Issued By: D. Anthony Rubin
BID NO.: 18-18004

FORMAL INVITATION FOR BIDS
EMERGENCY CONTRACT FOR CLEANING DIGESTERS AT THE DOS RIOS WRC
ADDENDUM NO. 1

This **Addendum no. 1** is being issued to revise the Price Schedule to reflect lump sum pricing, modify the specification and to provide response to the question submitted.

Drawing DM-M-01

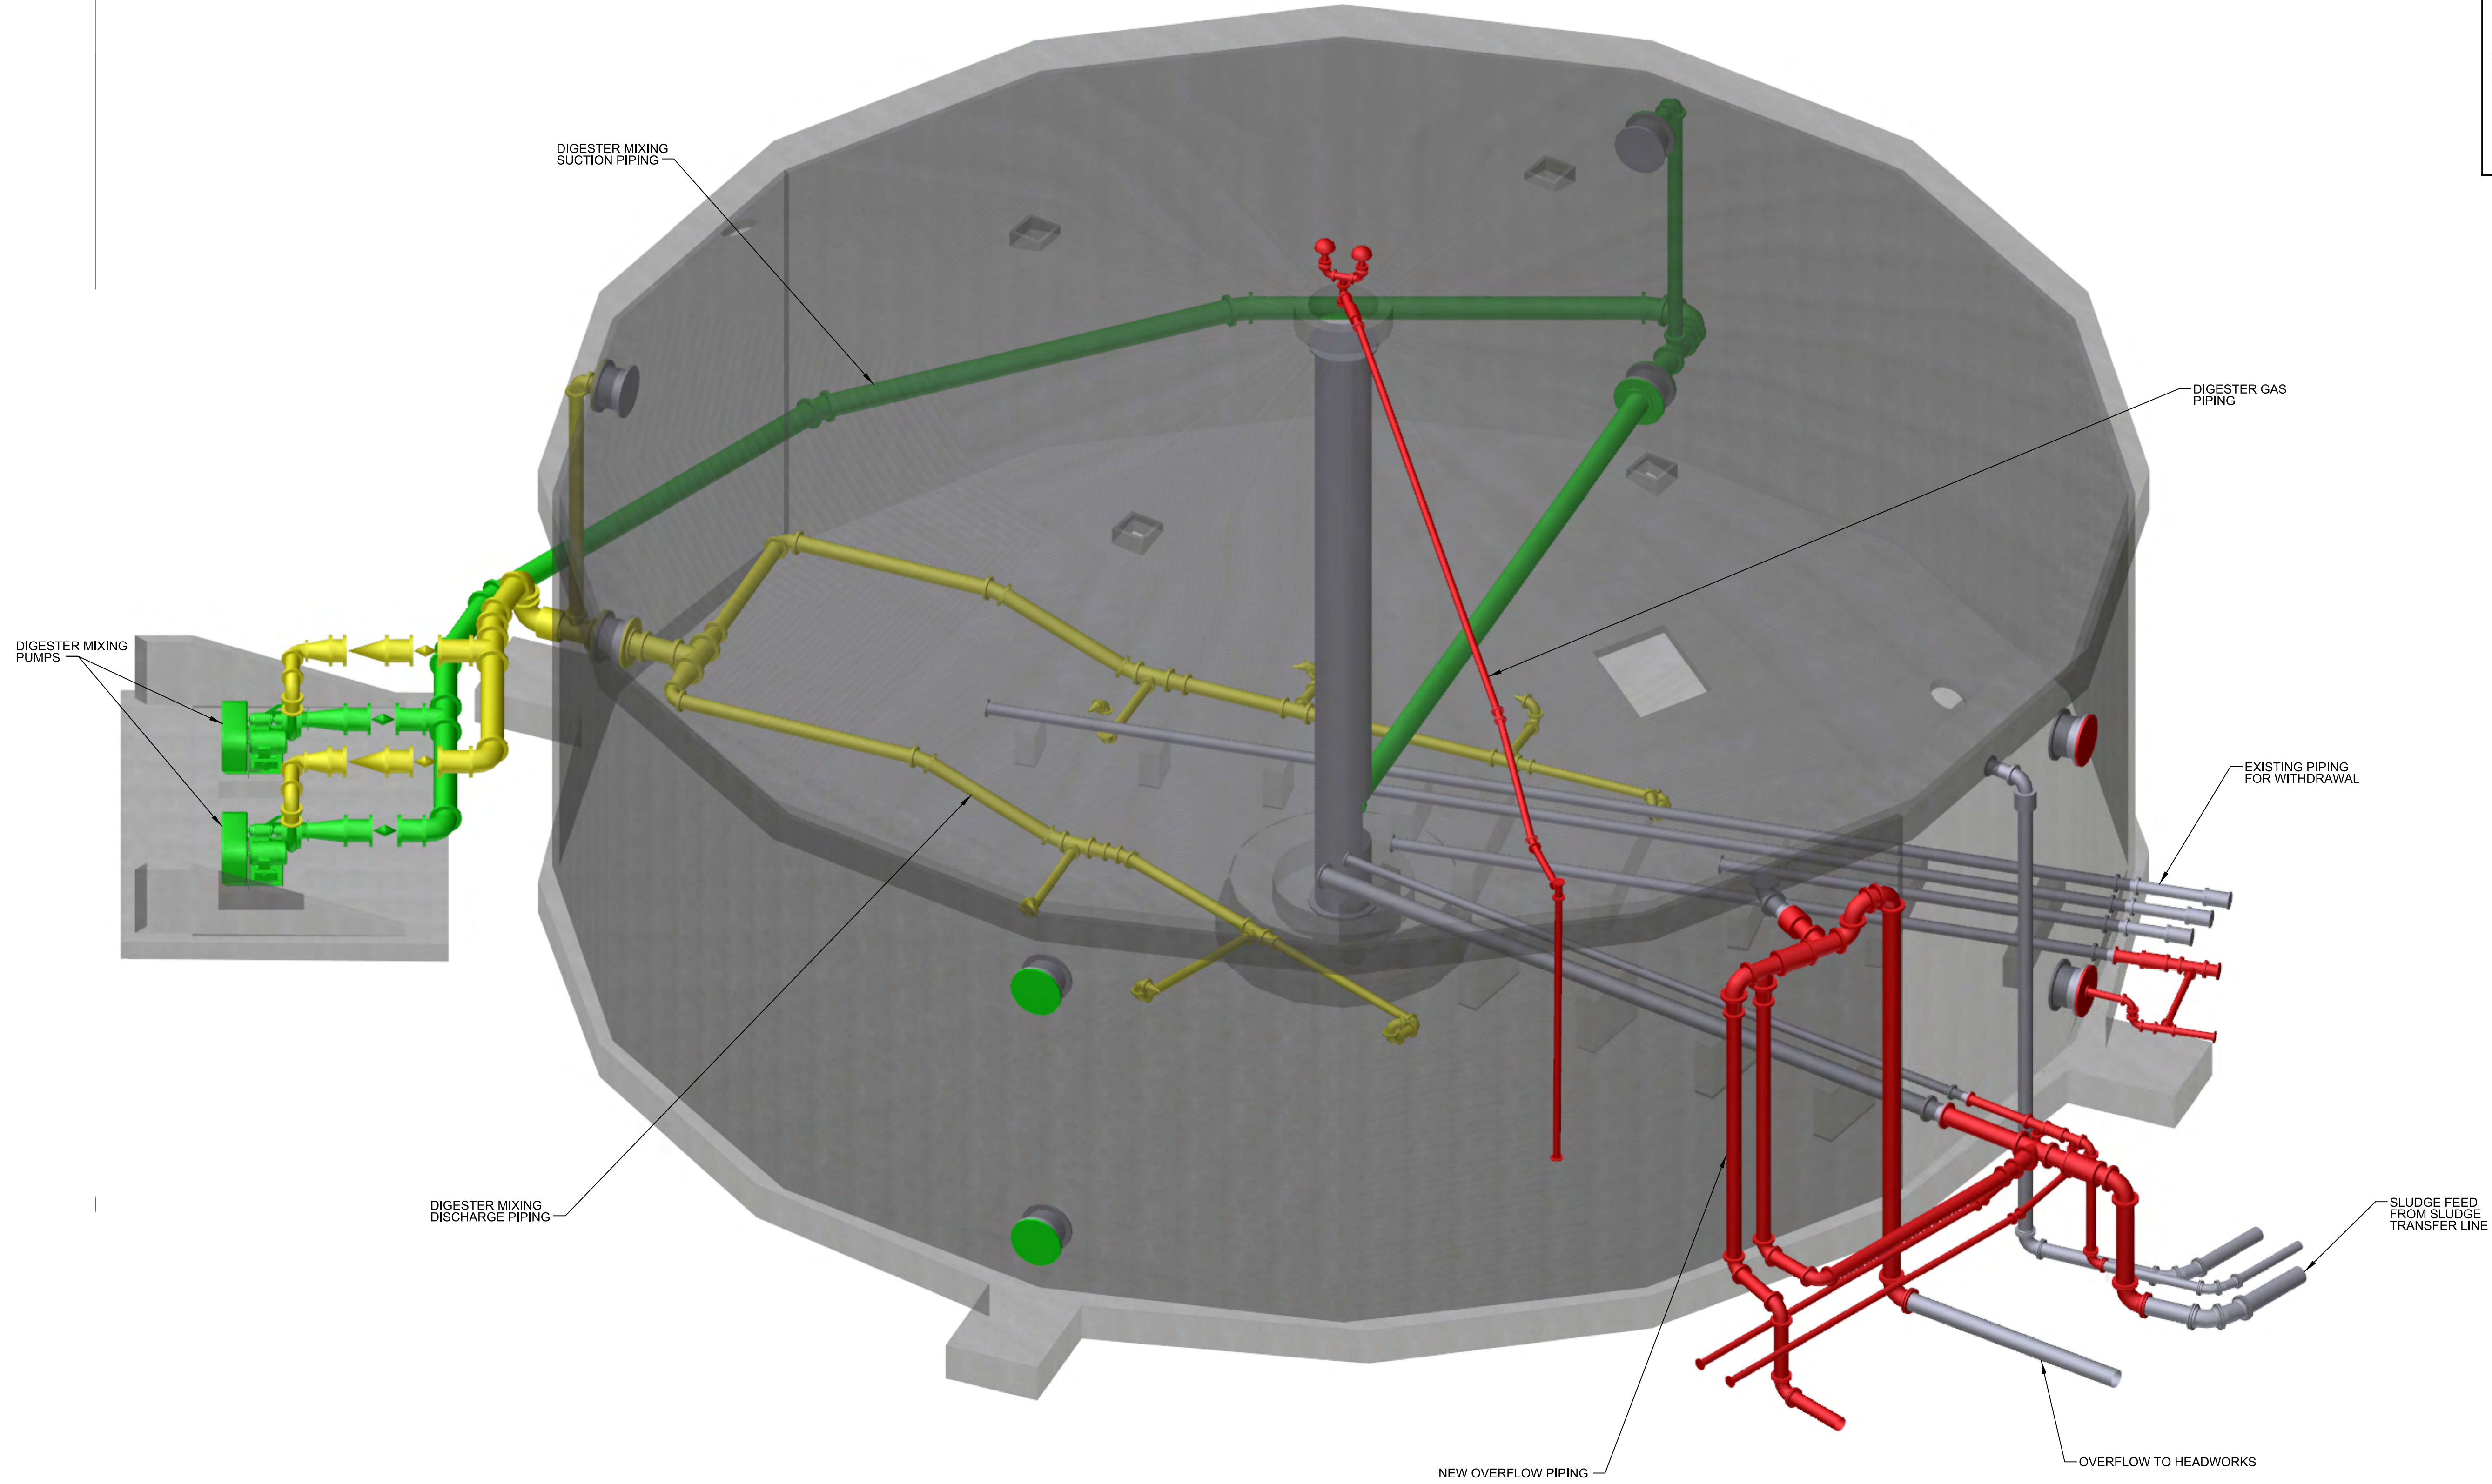
13. Please provide drawings of the mixing system in digester #4? **Answer:** This will be posted along with the addendum.
14. Lump sum pricing is requested. It is assumed that it should be assumed that the digester would be one third full at the start of the work which would mean the tank would be 10' full on the sidewall. Is this correct?
